UNITED STATES PATENT AND TRADEMARK OFFICE

APPLICATION NO.	FILING DATE	FIRST NAMED INVENTOR	ATTORNEY DOCKET NO.	CONFIRMATION NO.
10/049,854	05/21/2002	Johannes Andreas Stoffers	2001-1017	2462

**Office Action Summary**Application No.  
**10/049,854**Applicant(s)  
**Stoffers et al.**Examiner  
**YVONNE M. HORTON**Art Unit  
**3635**

## **DETAILED ACTION**

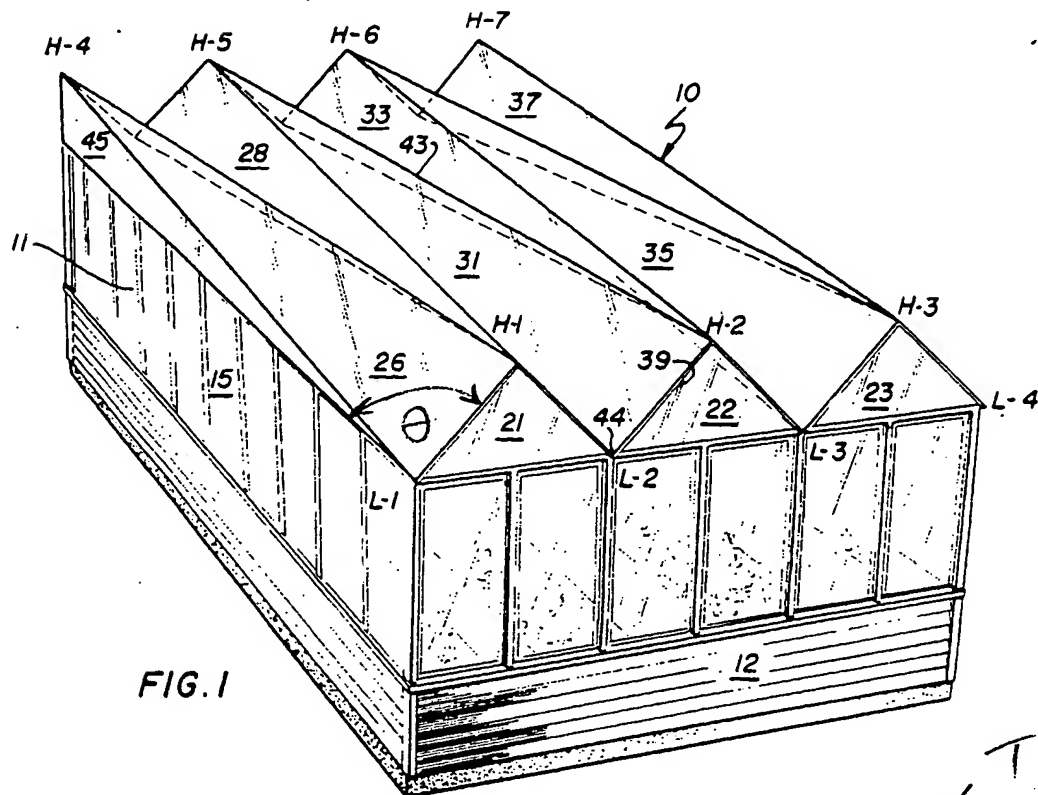
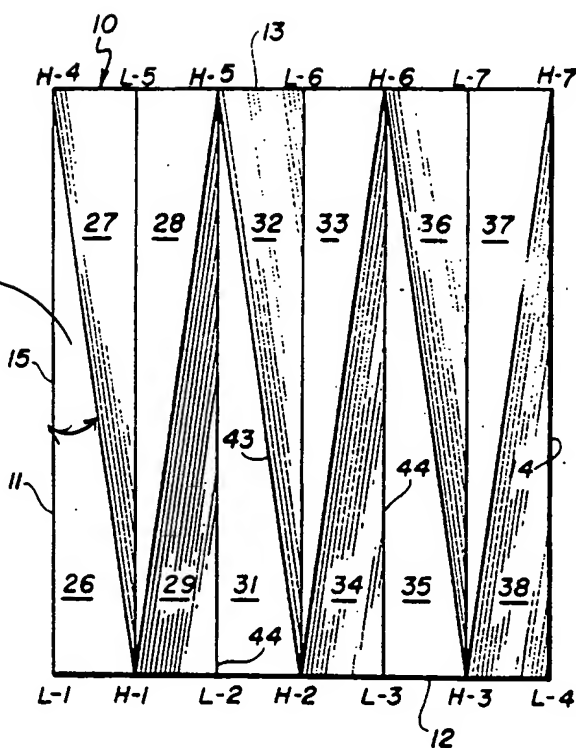
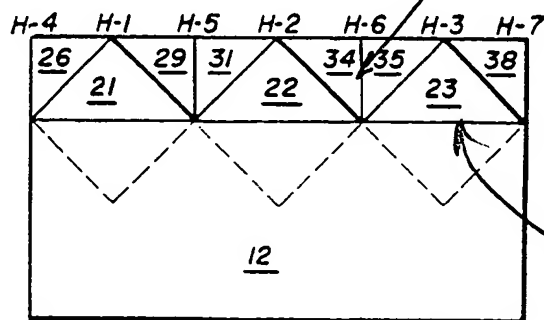
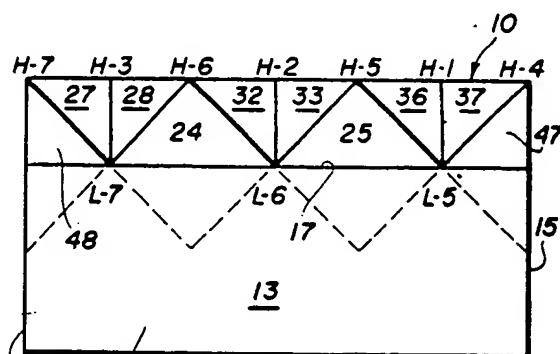
4. Claims 1-4, 7 and 8 are rejected under 35 U.S.C. 102(b) as being anticipated by US Patent #4,671,025 to BUTLER. BUTLER discloses the use of a transparent roof assembly, column 2, line 22, including a longitudinal direction along (11,14) and a transverse direction (12,13) perpendicular thereto; wherein the assembly further includes a plurality of pairs of first surfaces (21-25) extending along the transverse direction (12,13) and meeting at an apex (H1-H7) and a

second pair of surfaces (26-38) extending along the longitudinal direction (11,14) and also meet at the apexes (H1-H7). The surfaces (21-25) extend at an angle ( $\Theta$ ) to the base (11,14) and the surfaces (26-38) extend at an angle ( $\gamma$ ) to the base (11,14). Regarding claim 2, the longitudinal edges (11,14) and transverse edges (12,13) form a rectangle and the common apexes (H1-H7) are disposed above the rectangle formed by (11-14). In reference to claim 3, the first surfaces (21-25) touch the second surfaces (26-38) at the apexes (H1-H7). Regarding claim 4, the surfaces (21-25) and (26-38) are double walled in that they each include a base (B) and transverse links (T), see the marked attachment.
